6.4 Noise and Vibration

North Byron Parklands | Tweed Valley Way & Jones Road

Figure | 6.11
Modelled Music Stages

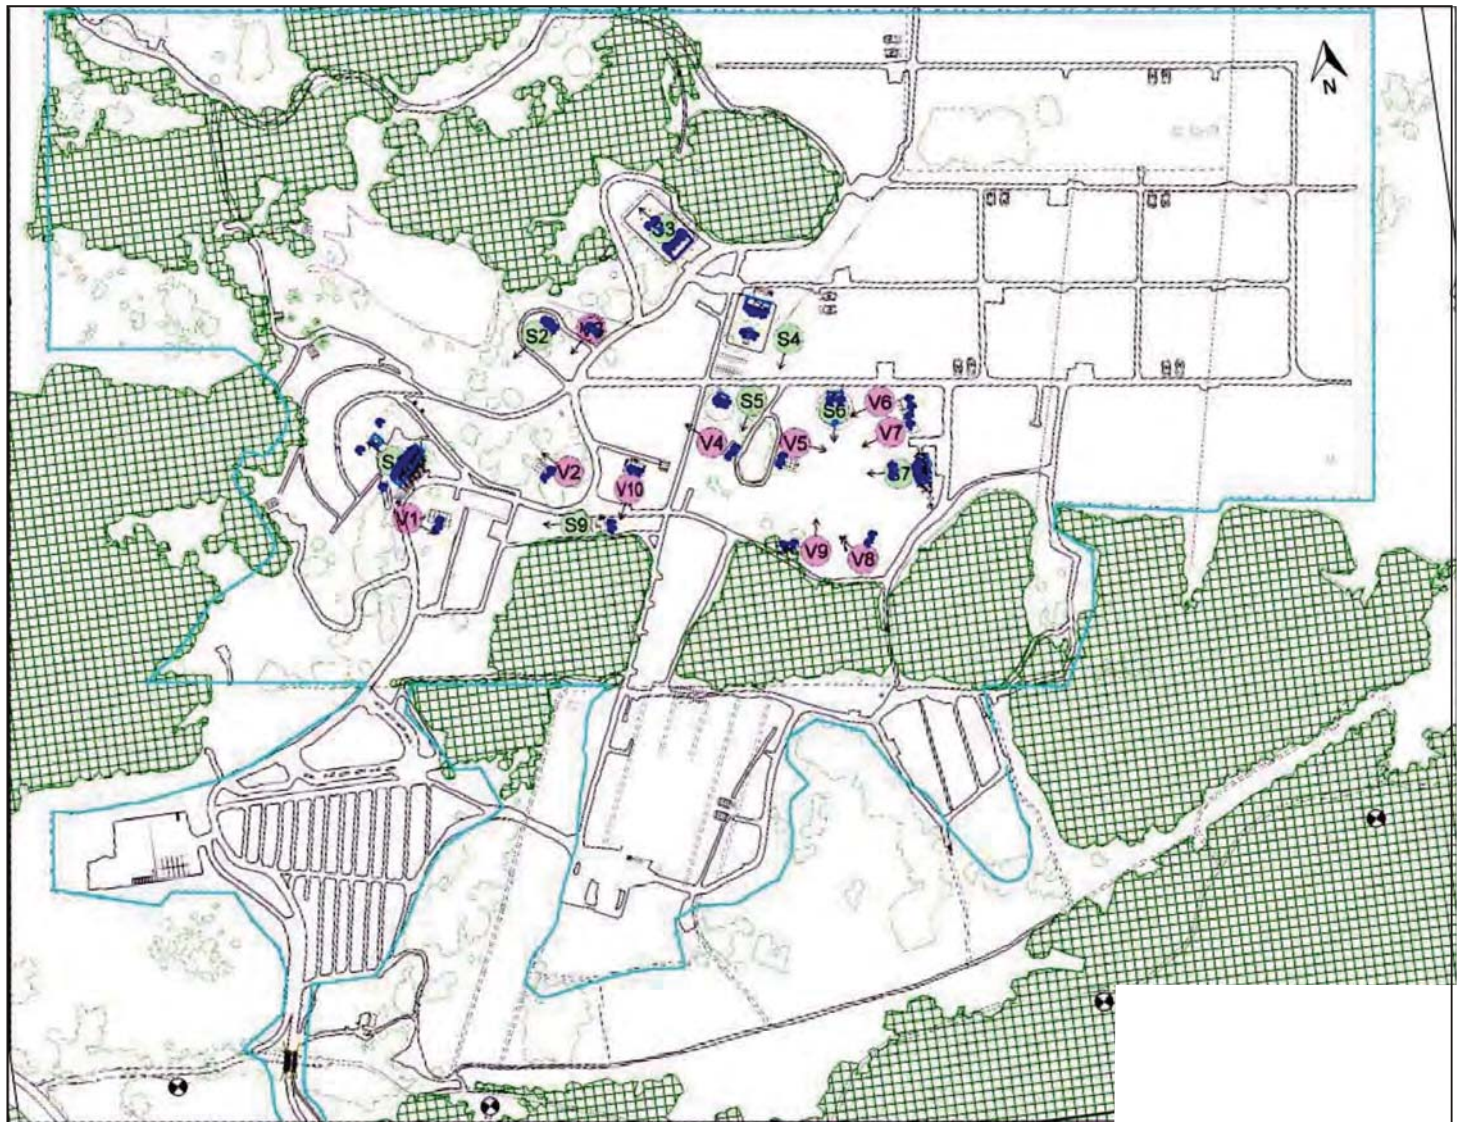
But only based on 11am to midnight data. No calibration between midnight and 2am with measurement data. There appears to be significant discrepancies between midnight-2am in particular
